BEFORE THE ENERGY RESOURCES CONSERVATION AND DEVELOPMENT COMMISSION OF THE STATE OF CALIFORNIA

IN THE MATTER OF COMPLAINT AGAINST THE EL SEGUNDO ENERGY CENTER PROJECT

Docket No. 12-CAI-03 Docket No. 00-AFC-14C

[PROPOSED] COMMISSION ORDER ADOPTING THE SETTLEMENT AGREEMENT AMONG THE PARTIES TO THE COMPLAINT AGAINST THE EL SEGUNDO ENERGY CENTER

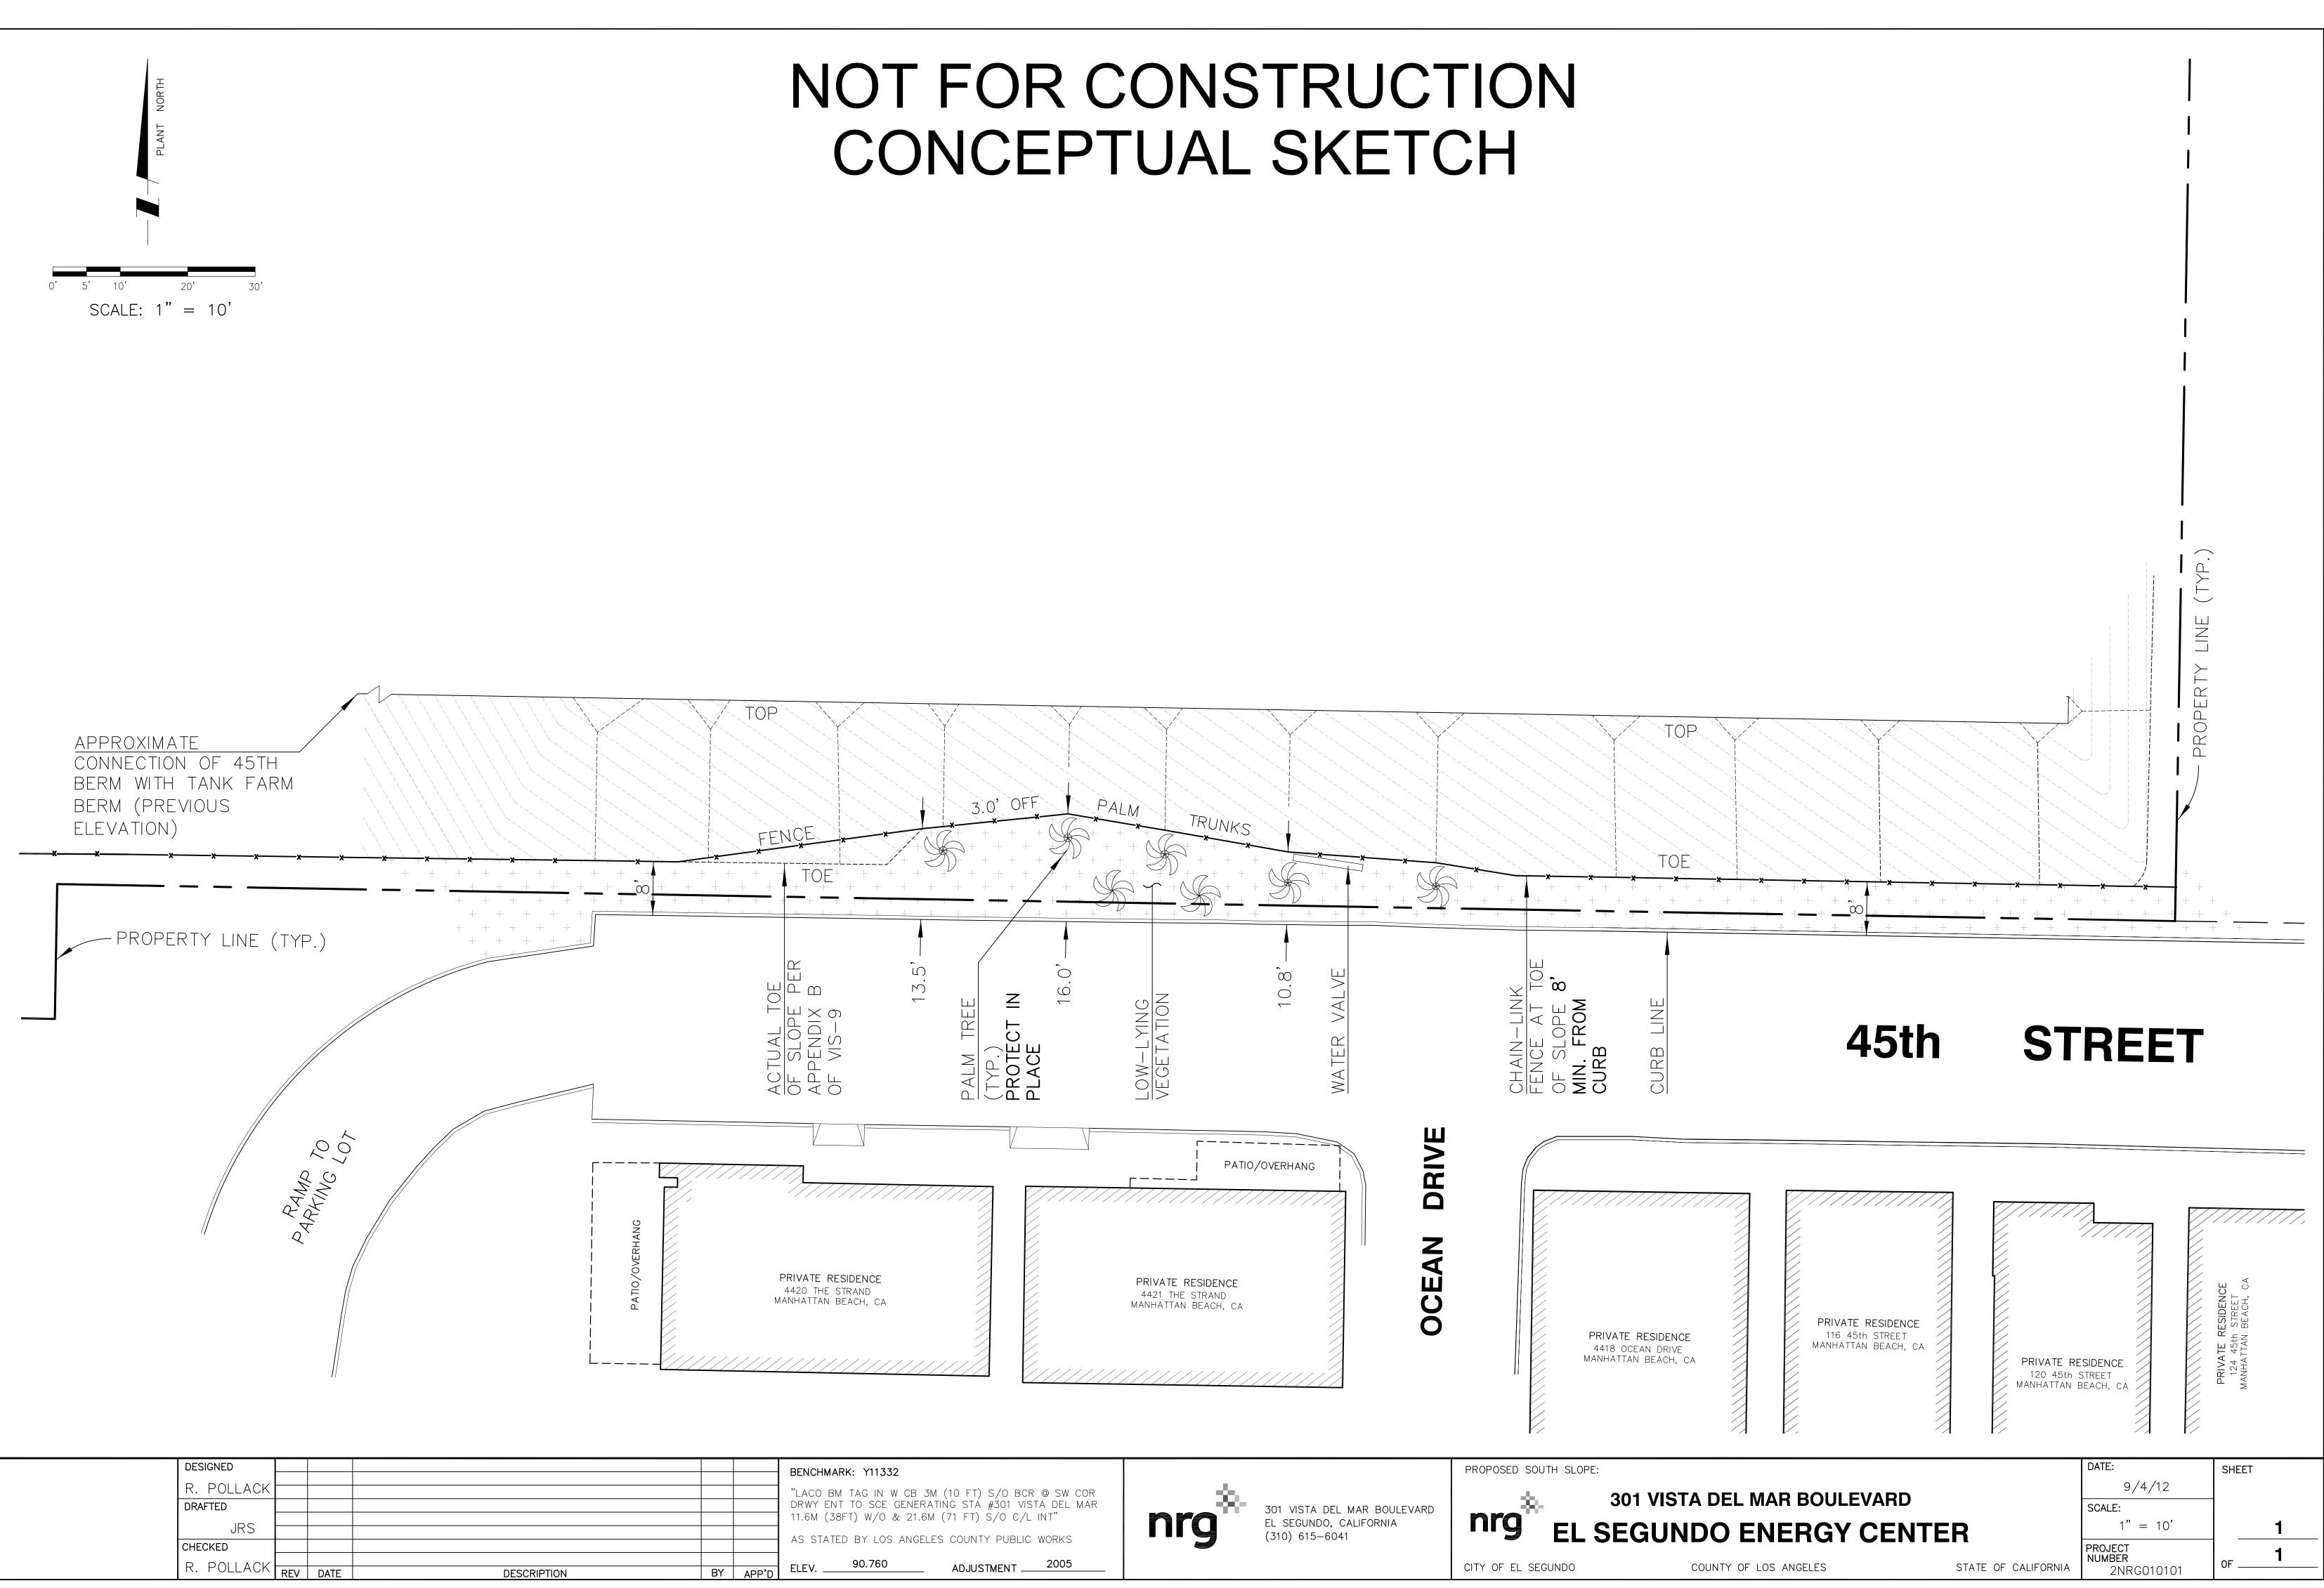
- a. The Parties jointly agree that the steepness of slope of the new 45th Street berm shall be increased in the area of the existing potable water valve and existing palm trees so the toe of the slope doe not reach the trees and that the existing palm trees shall be retained and incorporated into the landscaping. A general depiction of intended location of the toe of the slope is provided in Attachment A to this document.

similar to historic fence location. The Parties recognize that the exact location of the fence was never strictly decided in the past and that documents differed on its location. The Parties also acknowledge that a temporary fence on the southern property line is necessary during construction of the southern area landscaping features but that it will be replaced with the permanent fence promptly upon completion of the landscaping along the southern perimeter. A general depiction of the intended location of the fence is provided in Attachment A to this document.

- 5) ESECL agrees to prepare and submit to the City of Manhattan Beach, the City of El Segundo and the Parties for comment and then to the Compliance Project Manager (CPM) for approval, a revised 45th Street Berm Drawing (Appendix B to the *Temporary Landscaping and 45th St. Berm Vis-9* landscaping plan) that reflects the increased slope steepness to pull the slope back from the existing palm trees. The drawing should be consistent with the sketch provided as Attachment A.

- 6) ESECL agrees to prepare and submit to the City of Manhattan Beach, the City of El Segundo and the Parties for comment and then to the CPM for approval a revised sheet number 4 to Appendix A of the *Temporary Landscaping and 45th St. Berm Vis-9* landscaping plan showing the revised berm slope and exact final location of the permanent fence along the southern property line. The drawing should be consistent with the sketch provided as Attachment A.
- 7) ESECL agrees the project is subject to the noise ordinances of the Cities of El Segundo and Manhattan Beach and affirms it will comply with those ordinances at all times.
- 8) Based on the foregoing agreement, the Parties jointly request the following:
 - 1. CEC staff concurrence with this agreement and
 - 2. an order from the CEC resolving the Complaint that directs ESECL to conform to the terms of this agreement.
